Title: **STAGE 1 ROAD SAFETY AUDIT**

**Proposed Mixed Use Development , Swords Road, Santry,
Dublin 9.**

Client: **DBFL Consulting Engineers.**

Report reference: **1061R02**

Drawing 200060-X-04-X-DTM-DR-DBFL-CE-1301 Rev 0

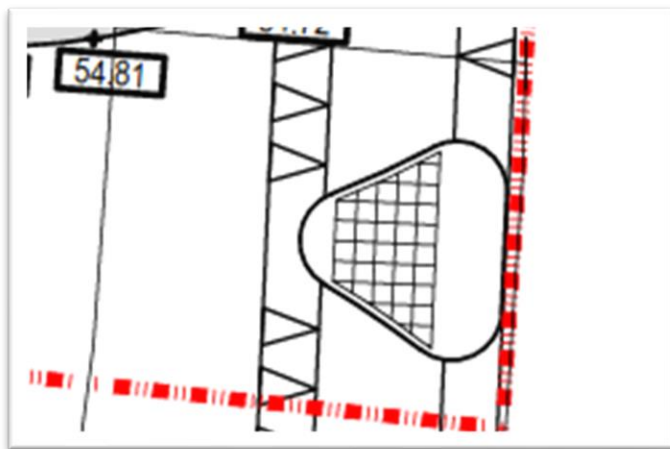
The junction of the access road to the South of the site appears to be a left in-left out junction (confirmed in the Traffic & transport Assessment provided by way of background information). It was observed during the site visit that the junction is not signed as such and drivers are turning right into it. The shape of the splitter island could lead to drivers entering the access road on the wrong side of the splitter island resulting in head-on collisions.

It is recommended that the signage and road markings relating to the left-in left-out only junction be provided or that the splitter island be reconfigured to allow all movements at the junction.

3.1	Yes	No	This junction has already received planning permission under Planning Ref.:2713/17 and is under construction. 'No Right Turn' signs can be facilitated within site boundary. The turn from Swords Road is under the control of the Local Authority and they will be made aware of the potential issue.	Yes

Drawing 200060-X-04-X-DTM-DR-DBFL-CE-1301 Rev 0, R132/Santry Avenue Junction.

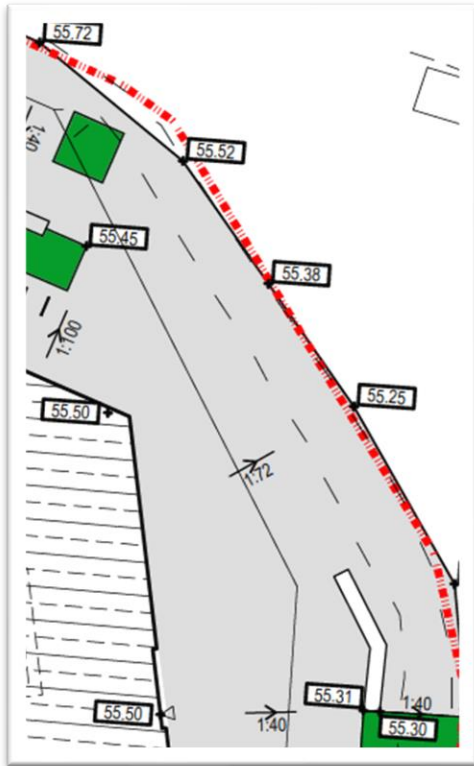
The corner radius of the R132/Santry Avenue junction is very large. This leads to high turning speeds and higher injury severities if pedestrians or cyclists are struck. There will be an increase in pedestrian activity at this junction as a result of the proposed development and there will be a corresponding reduction in heavy goods vehicles due to the replacement of the hardware premises. There is an existing issue with pedestrian collisions in that area as observed from the RSA data.

It is recommended that the corner radius is reduced at the junction.

3.2	Yes	No	This area is outside the site boundary and under the control of the Local Authority. The current footpath layout and radius is under review as part of the "BusConnects" scheme. The "BusConnects" DRAFT plans show a reduction of the radius and a more pedestrian friendly junction.	Yes

Drawing 200060-X-04-X-DTM-DR-DBFL-CE-1301 Rev 0, Santry Avenue.

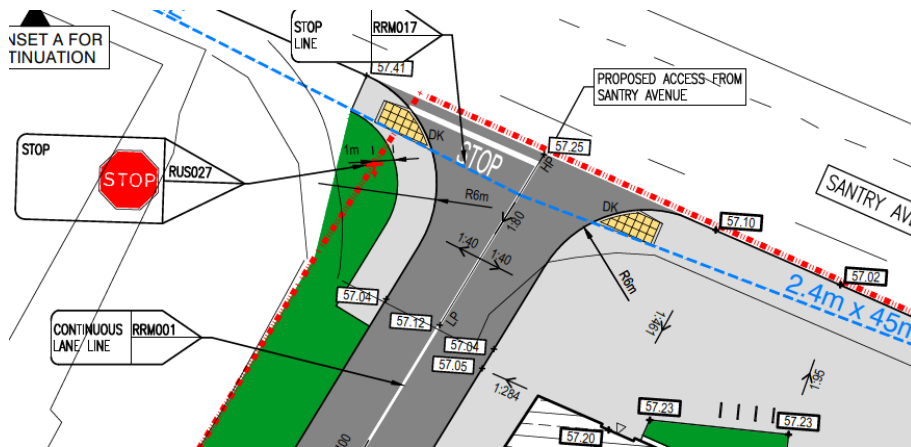
The proposed vehicular access off Santry Avenue is opposite an on-road bus stop (Route 17A) which is currently slightly built-out from the through kerb line. Drivers may exit from the proposed development when other drivers are overtaking parked buses which could lead to head on-or side swipe collisions.

Ensure that the proposed access does not compromise the safety of road users when busses are stopped on Santry Avenue. This may require the relocation of the bus stop.

3.3	Yes	No	Relocation of the bus stop is outside the site boundary and under the control of the Local Authority.	Yes
3.4	Yes	Yes	The recommendation will be incorporated during detailed design stage.

Drawing 200060-X-04-X-DTM-DR-DBFL-CE-1301 Rev 0, Santry Avenue.

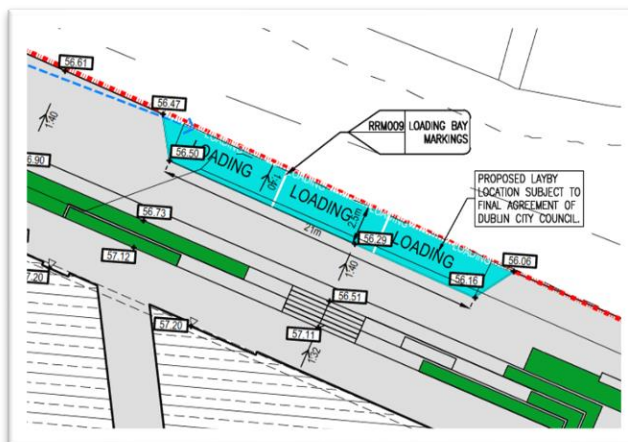
It is proposed to provide 3no. loading bays on Santry Avenue. It is unclear if there are routes for deliveries to the development that do not include steps or excessively long journeys. If the loading bays are not conveniently located there is a risk that delivery drivers may park on the footpaths and be hazards for pedestrians.

It is recommended that the loading bays be placed at convenient at grade locations for deliveries to/from the proposed development.

Drawing 200060-X-04-X-DTM-DR-DBFL-CE-1301 Rev 0, main Access Road.

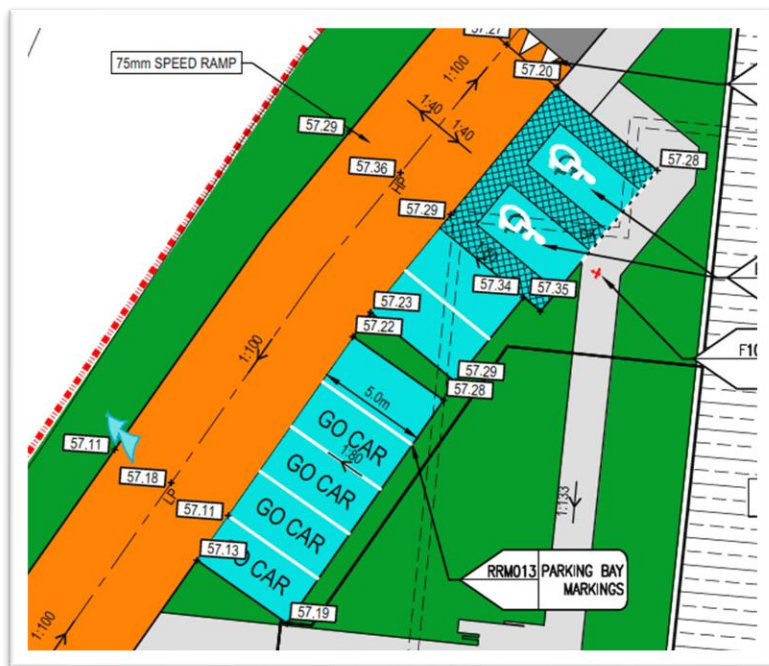
Occupants of the Go-Car parking spaces and one of the disabled spaces do not have an area of footpath to enter when they leave their vehicle. Those road users would have to enter the carriageway of the access road where they would have a greater likelihood of being struck by a passing vehicles.

It is recommended that a footpath be provided along the parking spaces and that dropped kerbs be provided at the disabled parking spaces to facilitate universal access. Although only indicative at this stage, signs should not be placed in the footways.

3.5	Yes	Yes		
3.6	Yes	Yes	The recommendation will be incorporated during detailed design stage.	
3.7	Yes	No	These radii are to accommodate larger vehicle (refuse/Fire Tender)	Yes

Drawing 200060-X-04-X-DTM-DR-DBFL-CE-1301 Rev 0, various locations.

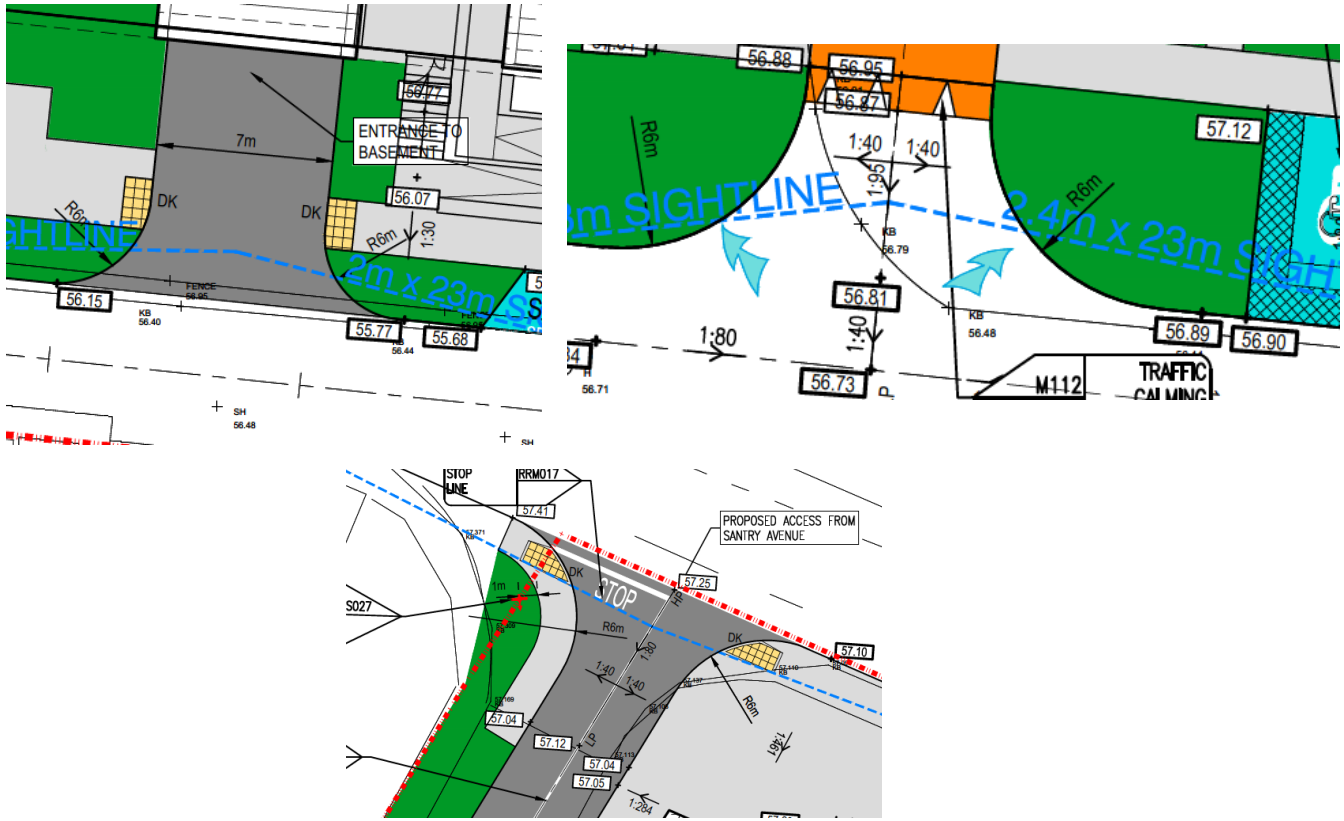
It is proposed to have 6m corner radii at all the vehicular accesses including the basement access. Larger corner radii can lead to higher turning speeds, greater distances for pedestrians to cross and greater likelihood of turning drivers not being able to see cyclists. Larger radii therefore lead to higher likelihoods and severity of collisions with vulnerable road users.

It is recommended that suitable corner radii be provided.

Paragraph No. in Safety Audit Report	Problem accepted (yes/no)	Recommended measure accepted (yes/no)	Alternative measures (describe)	Alternative measures accepted by Auditors (Yes/No)
			maneuverability and in line with DMURS.	
3.8	Yes	Yes	The recommendation will be incorporated during detailed design stage.

Drawing 200060-X-04-X-DTM-DR-DBFL-CE-1301 Rev 0, R132.

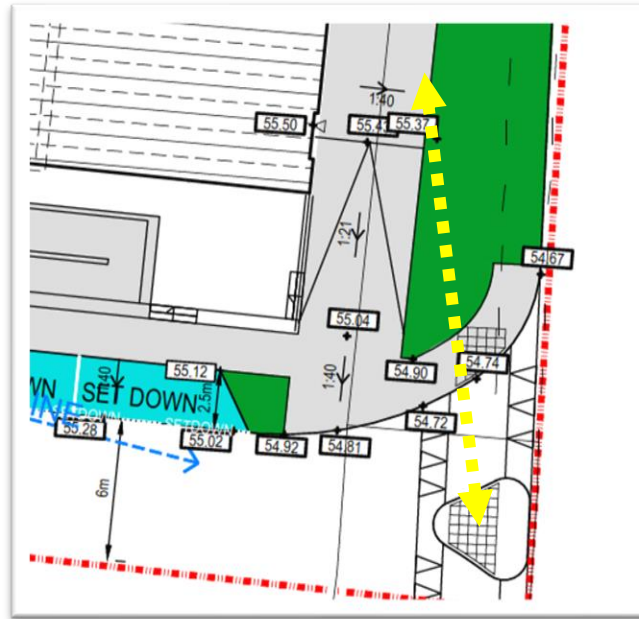
The proposed footpath along the R132 is set back from the kerb line due to the widened grassed verge. The proposed footpath does not align with the crossing at the southern access and is not along the desire line. This could lead to pedestrians not associated with the development travelling on the grassed verge which could lead to slips and falls.

It is recommended that a footpath be provided that caters for the desire line and crossing of the access.
